# Access Compliance Report

## Public Rights-of-Way

### (Curb Ramps)

Intersection ID: 50542	Main Street: LEMONGRASS_LN	Cross Street: THYME_CT	Location: SW
ADA ID: AB19DF27ACB6	Ramp Type: PerpDiag	Initial Pass/Fail: Fail	Overall Compliance: No
			Severity Score: 21.25

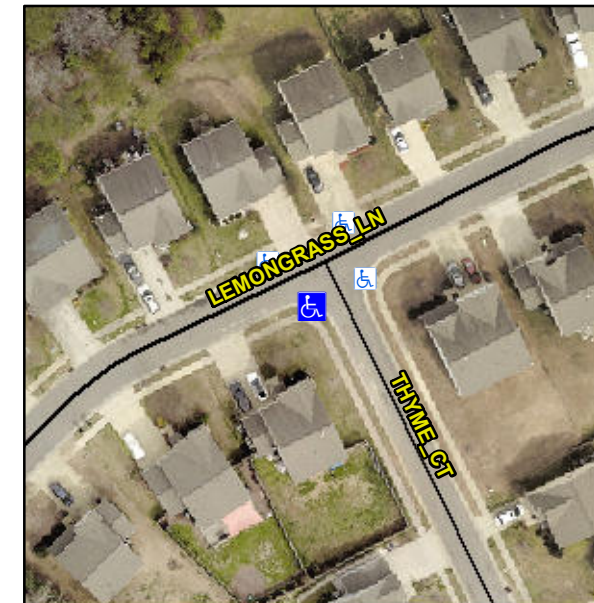
**Not Found, R304.5.1, R304.2.2**

Compliance	Description	Data	Compliance	Description	Data
N/A	Ramp Length (in)	45.0	No	Ramp Slope (%)	8.6
No	Ramp Width (in)	47.5	Yes	Ramp XSlope (%)	0.7
N/A	Flare Type LT	N/A	N/A	Flare Type RT	N/A
N/A	Flare Slope LT (%)	N/A	N/A	Flare Slope RT (%)	N/A
N/A	Flare Traversable LT?	N/A	N/A	Flare Traversable RT?	N/A
N/A	Landing Length (in)	N/A	N/A	DWS Provided?	N/A
N/A	Landing Width (in)	N/A	N/A	DWS Contrast?	N/A
N/A	Landing Slope (%)	N/A	N/A	DWS Length (in)	N/A
N/A	Landing X Slope (%)	N/A	N/A	DWS Full Width?	N/A
N/A	Landing Curb? (Y/N)	N/A	N/A	DWS Offset (in)	N/A
N/A	Shared Landing?	N/A			
N/A	Gutter Ponding?	N/A	N/A	Gutter Slope (%)	N/A
N/A	Gutter Lip Ht (in)	N/A	N/A	Gutter X Slope (%)	N/A
N/A	Painted X Walk1?	No	N/A	Painted X Walk2?	No
	X Walk 1 Direction	To E		X Walk 2 Direction	To N
N/A	X Walk 1 Width (in)	N/A	N/A	X Walk 2 Width (in)	N/A
	X Walk 1 Slope (%)	4.9		X Walk 2 Slope (%)	4.1
	X Walk 1 X Slope (%)	3.0		X Walk 2 X Slope (%)	3.2

**Remove & Replace Curb Ramp With Two New Directional Ramps or Equivalent.**
